**ENGINEERING, OPERATIONS AND PLANNING COMMITTEE MEETING  
AGENDA**

**DATE:** January 16, 2024  
**TO:** Engineering, Operations and Planning Committee  
**FROM:** Linda Jadeski, Assistant General Manager  
**SUBJECT:** CHANGE ORDER NO. 4 WITH PCL CONSTRUCTION, INC. FOR THE OLIVER P. ROEMER WATER FILTRATION FACILITY UPGRADE AND EXPANSION PROJECT

CHANGE ORDER

Order No. 4  
Date 1/8/2024  
Agreement Date 10/31/2022  
Sheet 1 of 2

1 UV RECOVERY PLAN  
C-141 SCALE: 1"=10'

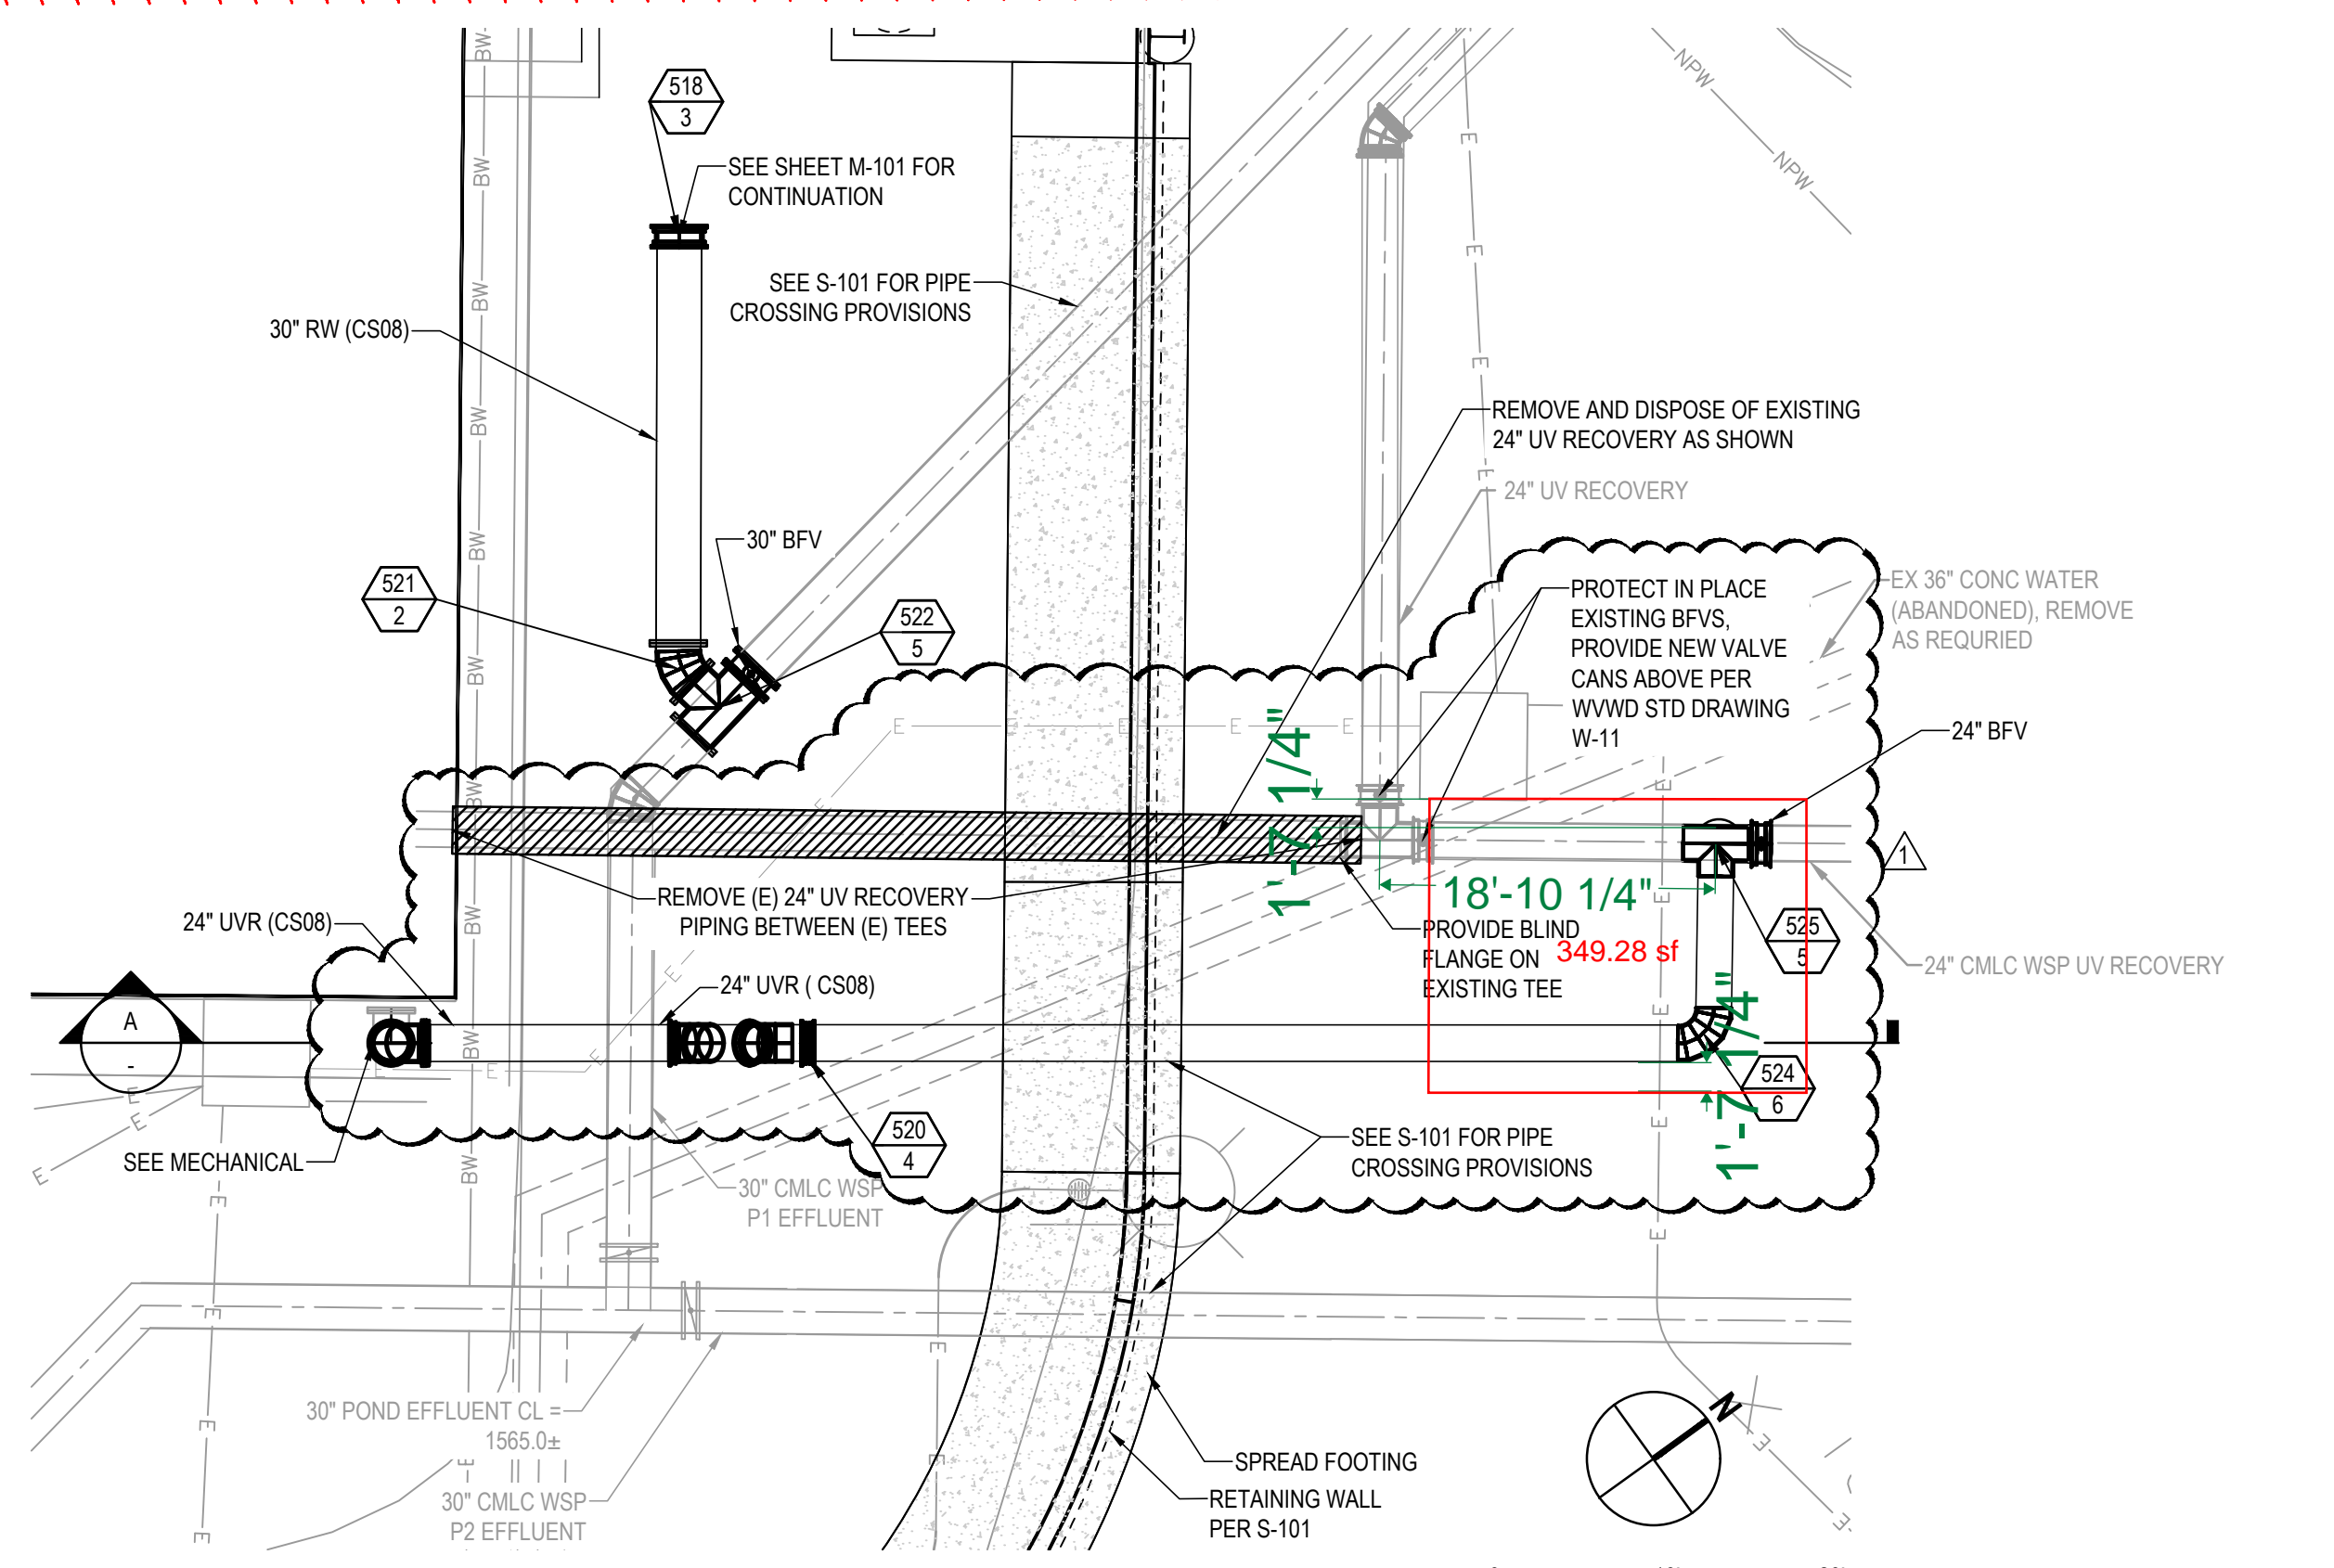
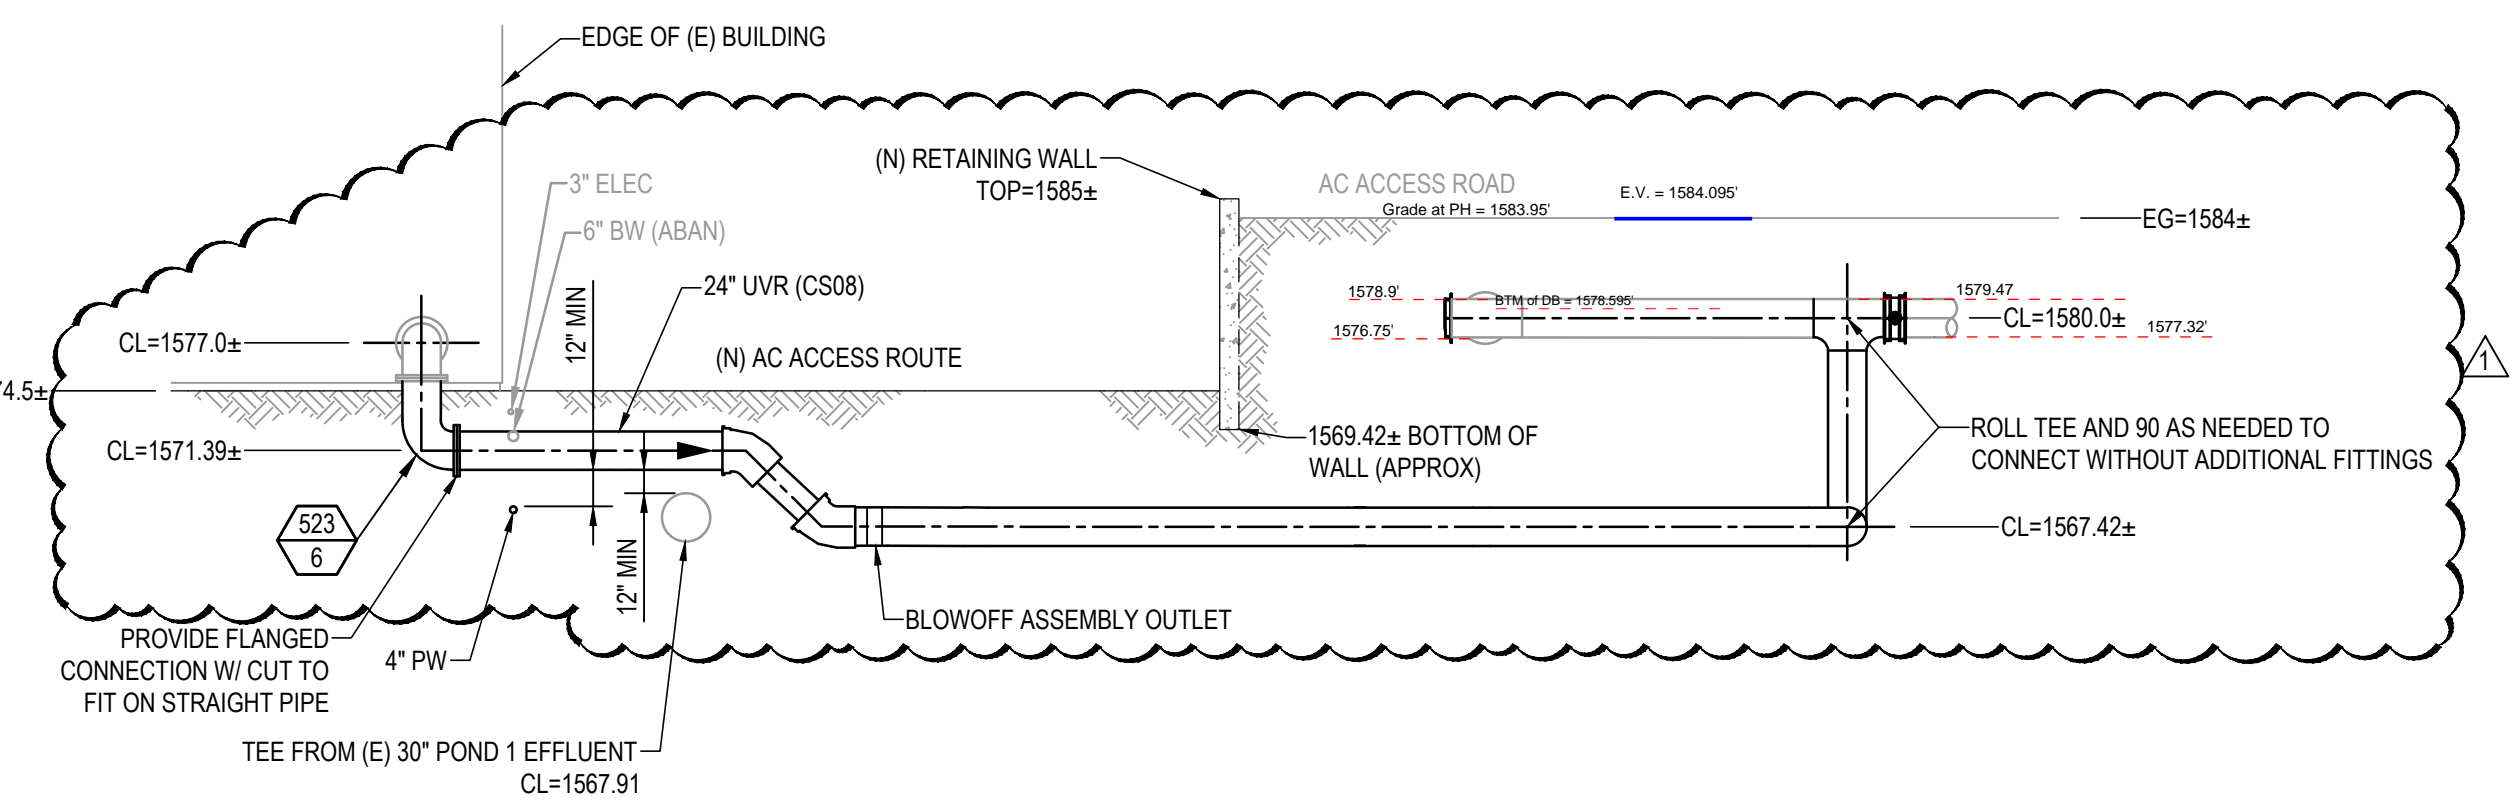
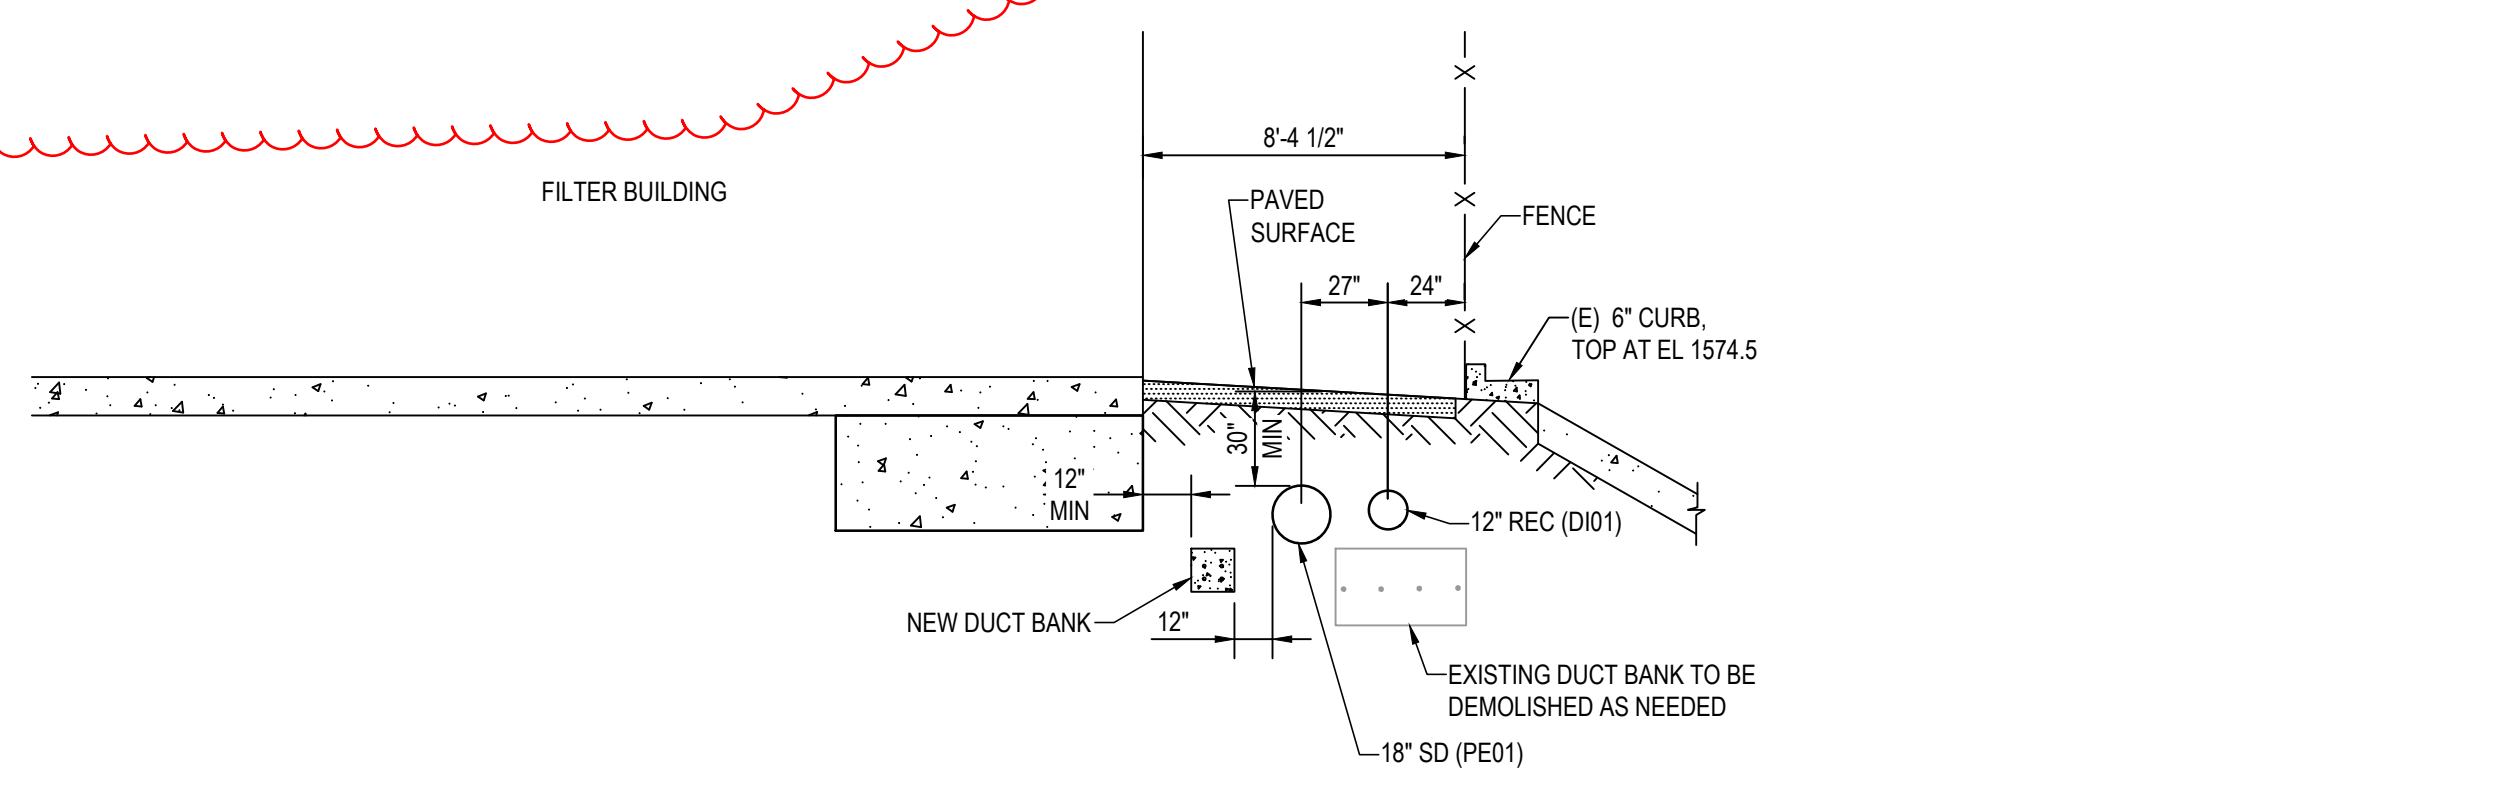
Please accept this correspondence as a Change Request regarding the impacts associated with the new reroute of the 24” UV Recovery Line. As informed to the District and GHD on June 27, 2023, The two existing electrical vaults HH-11 and HH-1, with wires that feed the building, are at different locations, compared to what they are shown on the 30% drawings and record drawings. HH-11 is closer to the existing/new 24” tie-in point than what is shown on the drawings. On the other hand, HH-1 is closer to the building than what is shown on the drawings as well. The current location of HH-11 does not allow the new 24” UV reroute to be tie-in next to the vault, as well as to reuse the existing butterfly valve. PCL sees that the discrepancy in the location of the existing vaults is a Differing Site Condition in accordance with the Prime Contract, section 4.2.

Updated UV recovery line for constructibility
